<b>AMENDMENT OF SOLICITATION/MODIFICATION OF CONTRACT</b>			1. CONTRACT ID CODE	PAGE 1 OF 24 PAGES
2. AMENDMENT/MODIFICATION NO. AMENDMENT NO. 0002	3. EFFECTIVE DATE 9/14/11	4. REQUISITION/PURCHASE REQ. NO.	5. PROJECT NO. (If applicable) 11-0117	
6. ISSUED BY CODE	jsy	7. ADMINISTERED BY (If other than Item 6) CODE See Item 6		
Officer in Charge of Construction MCI-East 1005 Michael Road Camp Lejeune, NC 28547-2521				
8. NAME AND ADDRESS OF CONTRACTOR (No., street, county, State and ZIP Code)		(X)	9A. AMENDMENT OF SOLICITATION NO. N40085-11-R-0117	
		X	9B. DATED (SEE ITEM 11) 9/9/11	
			10A. MODIFICATION OF CONTRACT/ORDER NO.	
			10B. DATED (SEE ITEM 11)	
CODE	FACILITY CODE

11-0117, Repair Applied Instruction Building, BB-50

- 1. Question:** The drawings are missing 3 sheets, LS-1, FP-1 AND FA-1.
- 1. Answer:** Drawings LS-1, FP-1, and FA-1 are attached and hereby incorporated into the RFP (Request for Proposals) dated 9 September 2011.

**SECTION 27 10 00  
Encl A  
RACK ELEVATION  
EXAMPLE**

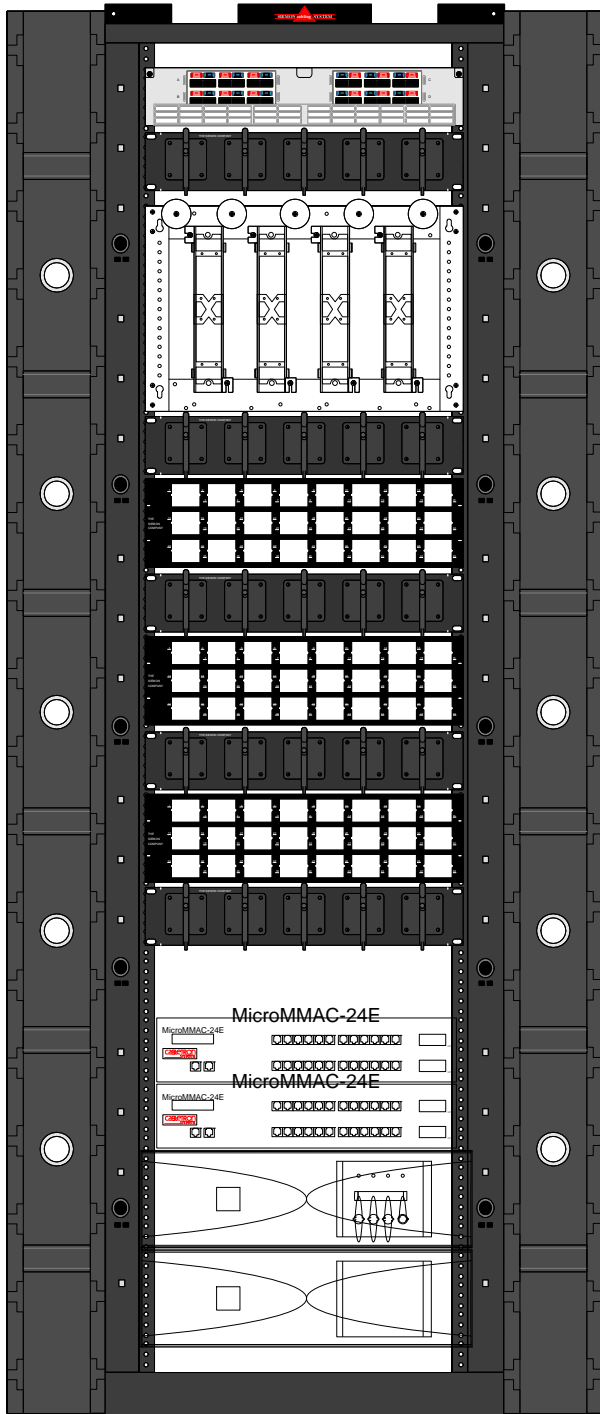
- 4.** Contractor shall intercept telecomm cabling to support additional outlets from the Blue Box Facility Entrance, as shown on attached sketch.
- 5.** Contractor shall follow the attached 27 10 00 STRUCTURED TELECOMMUNICATIONS CABLING AND PATHWAY SYSTEM specification for telecommunications installation. Also find the Quad Faceplate, Typical Backboard, and Typical Rack Elevation details attached.
